P&ID-CONTROL ROOM HVAC CVCO

WM. H. ZIMMER NUCLEAR POWER STATION UNIT
THE CINCINNATI GAS & ELECTRIC COMPANY
COLUMBUS & SOUTHERN OHIO ELECTRIC COMPANY
THE DAYTON POWER AND LIGHT COMPANY

DRAWING NO. M-86 SH. 2 of 4

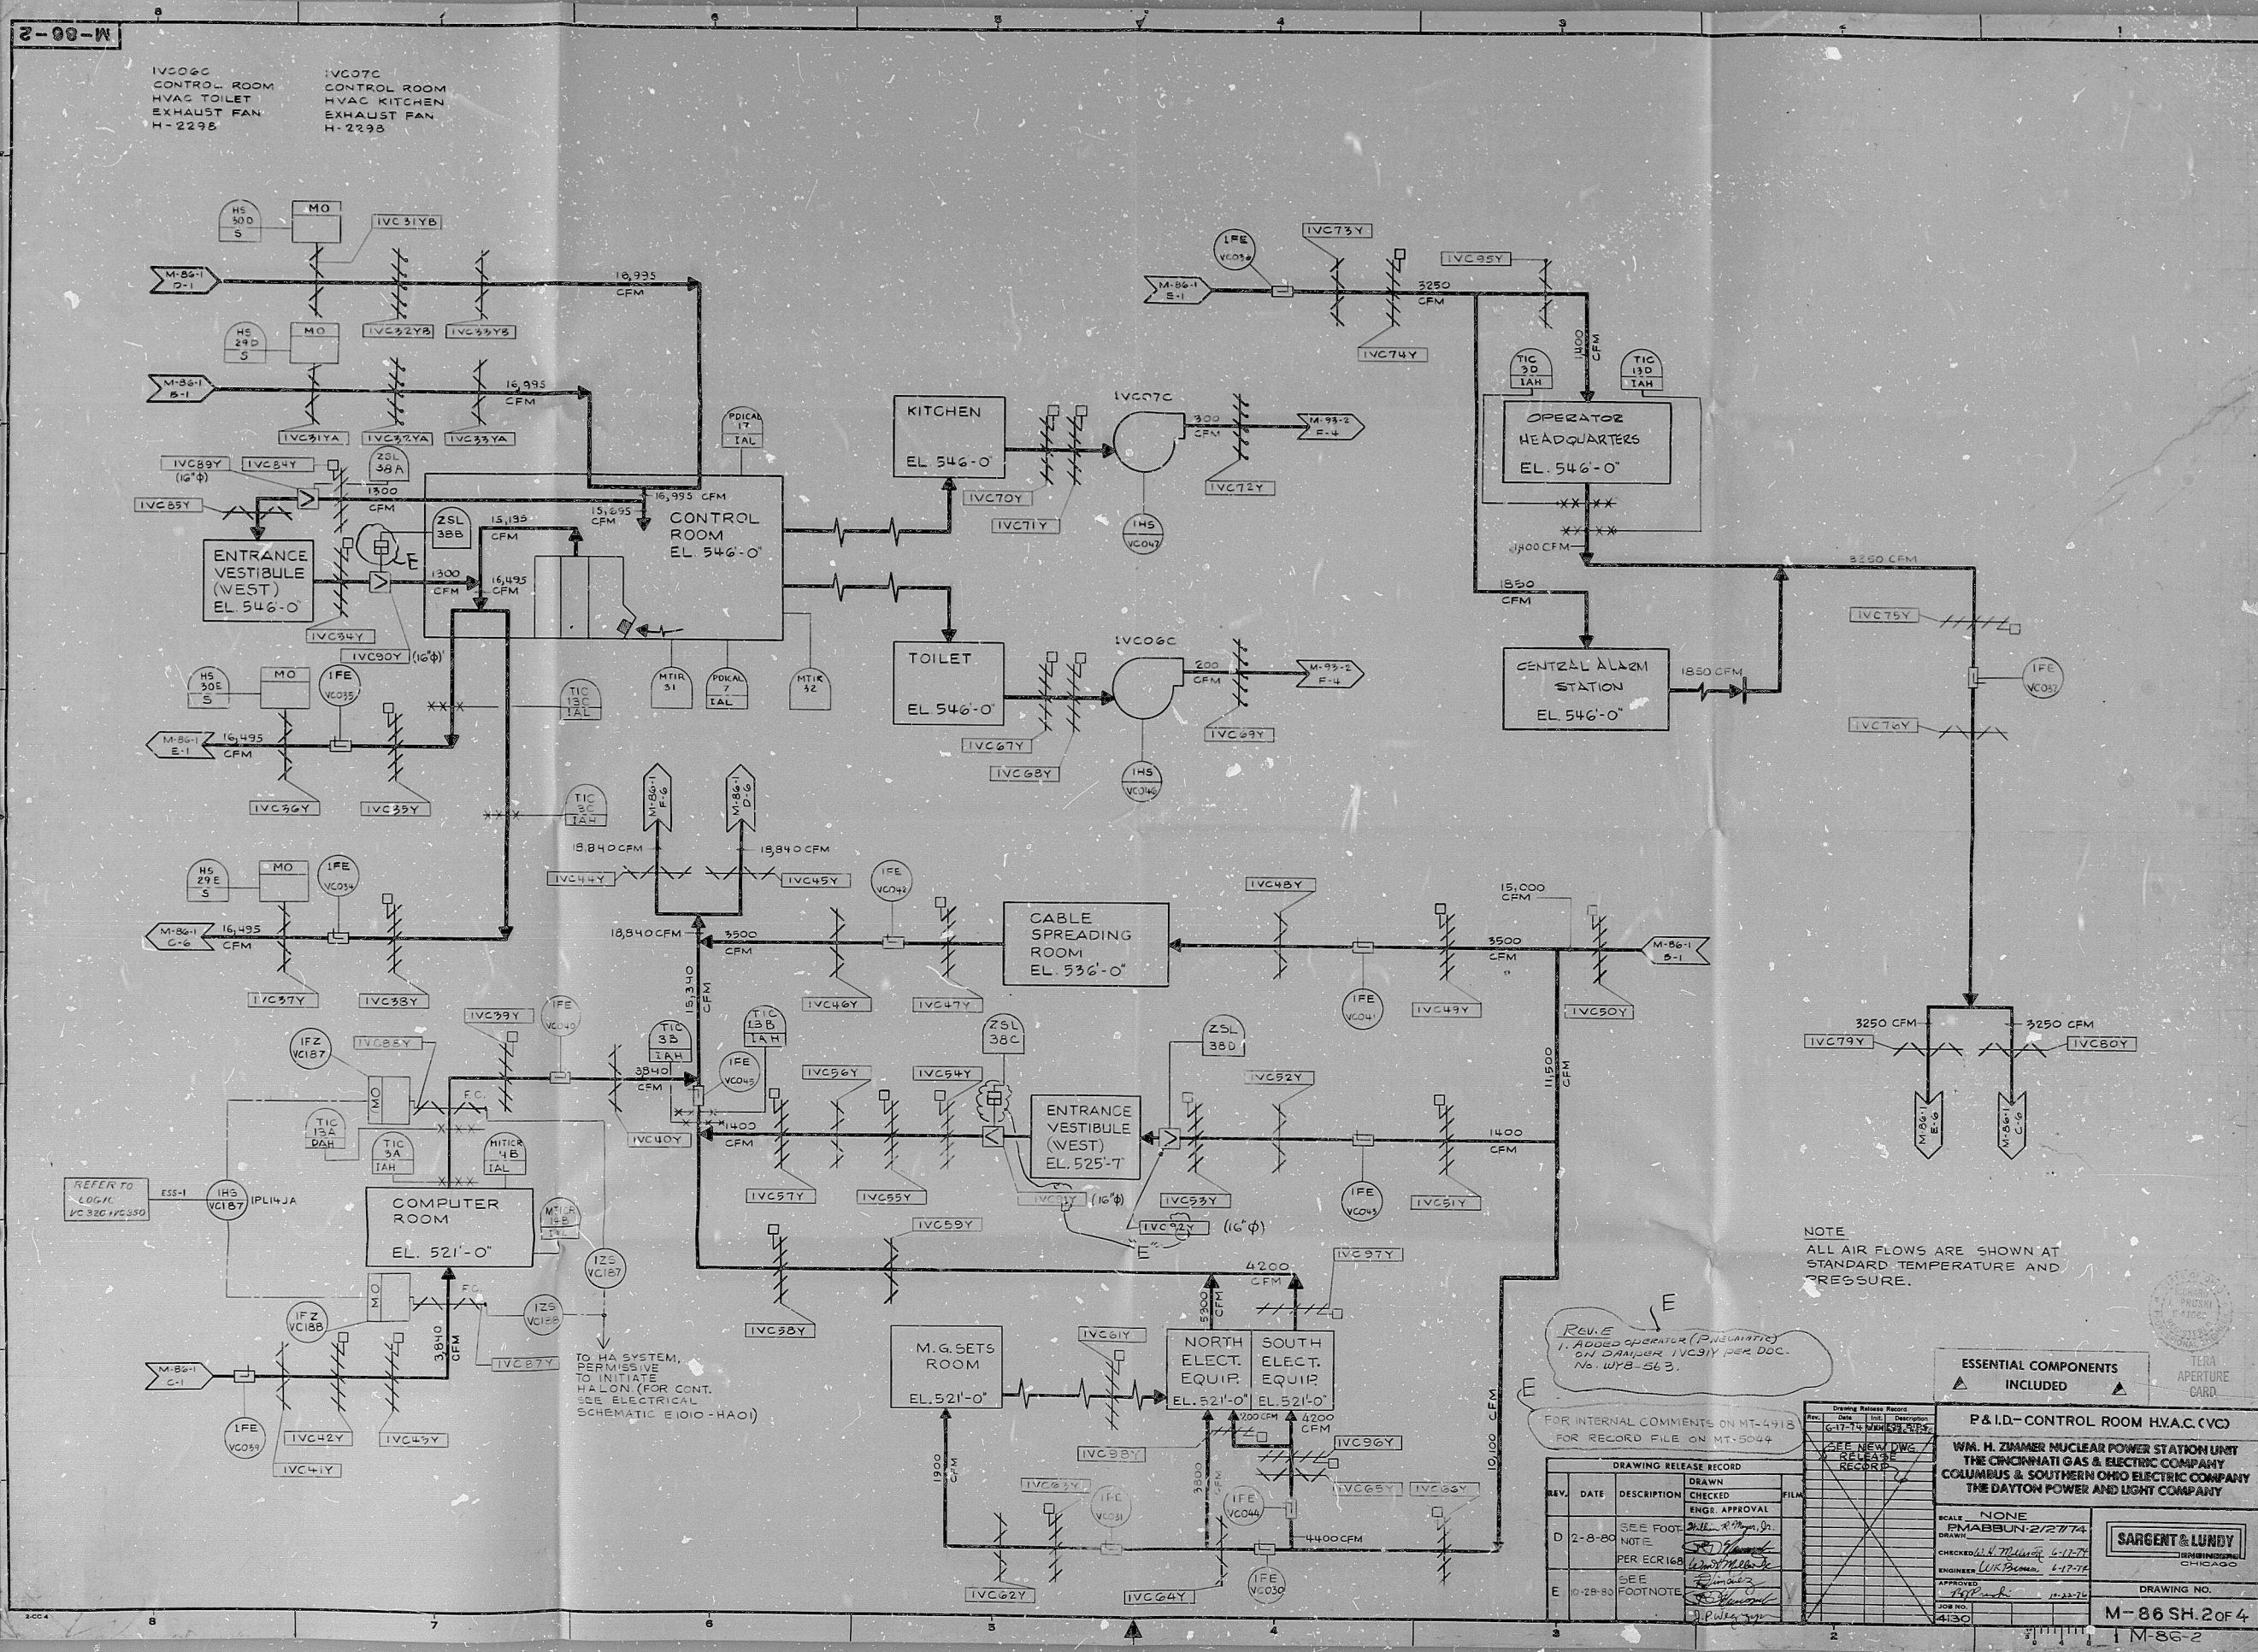
Revise
1. ADDED OPERATOR (PNEUMATIC)
ON DAMPER IVC31Y PER DOC.
No. WYB-563.
